NARROMINE TO NARRABRI

Map Book The proposal (design features)

MAP 199 OF 209

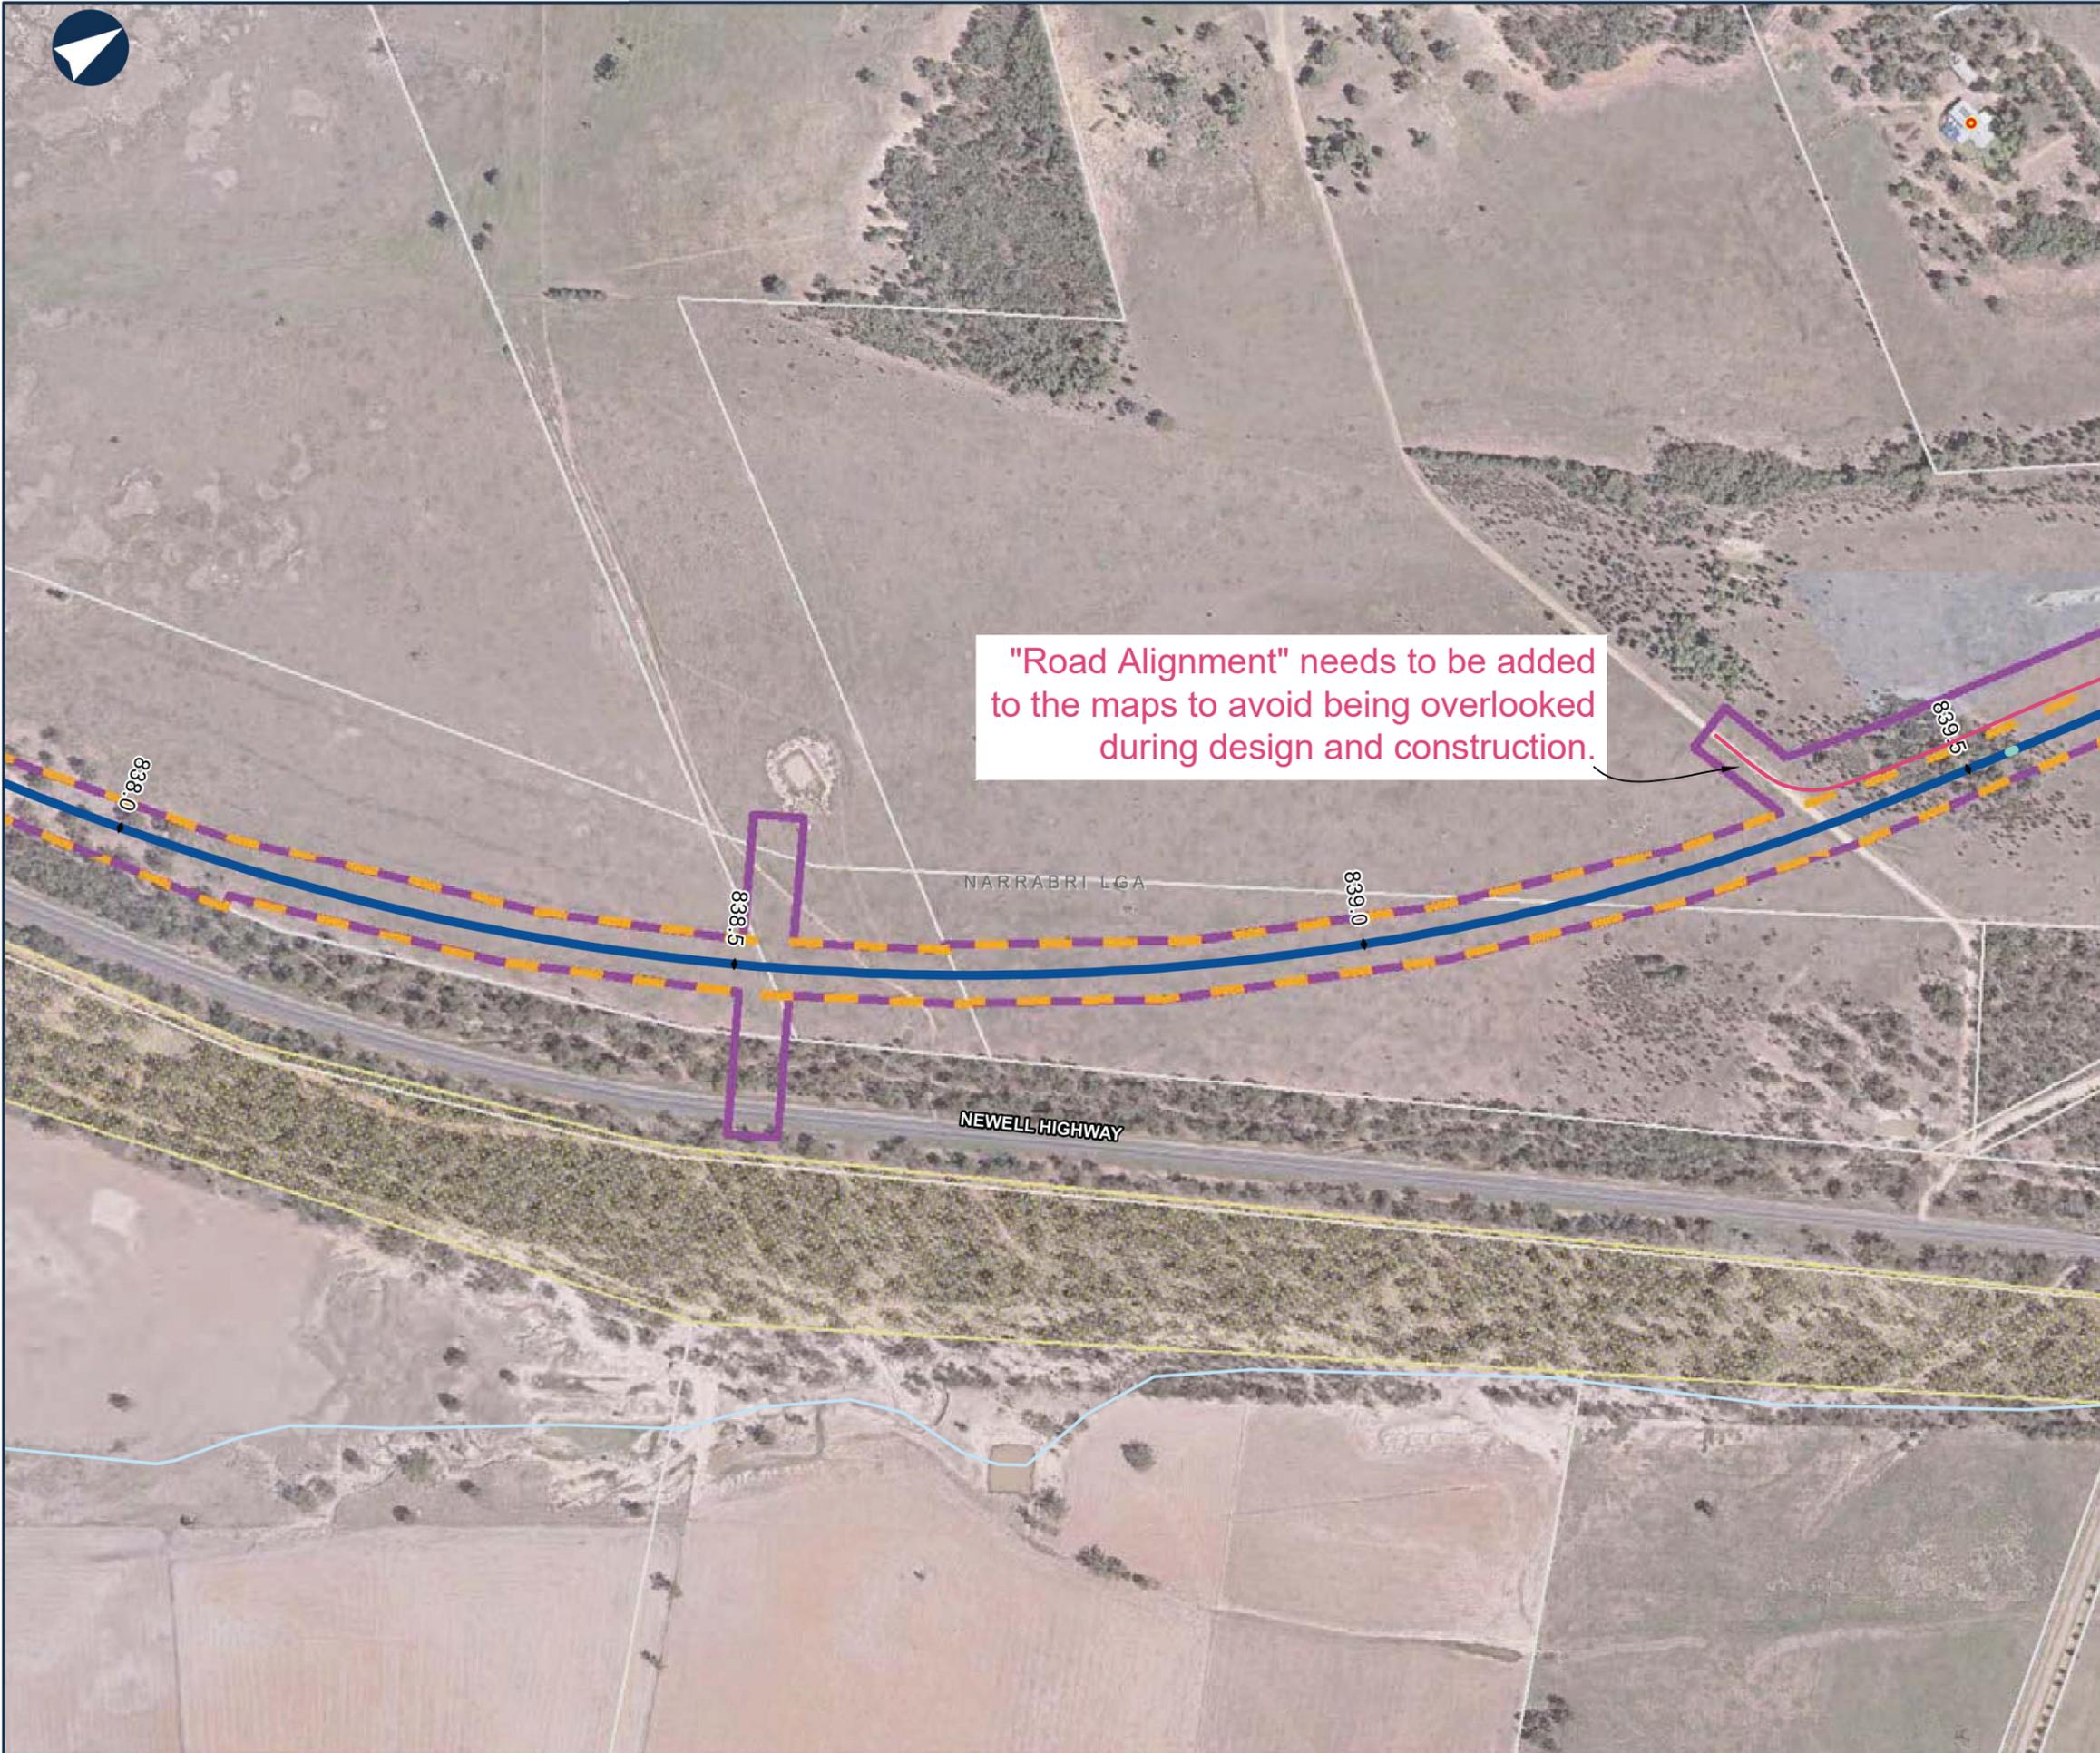
"Road Alignment" needs to be added to the maps to avoid being overlooked during design and construction.
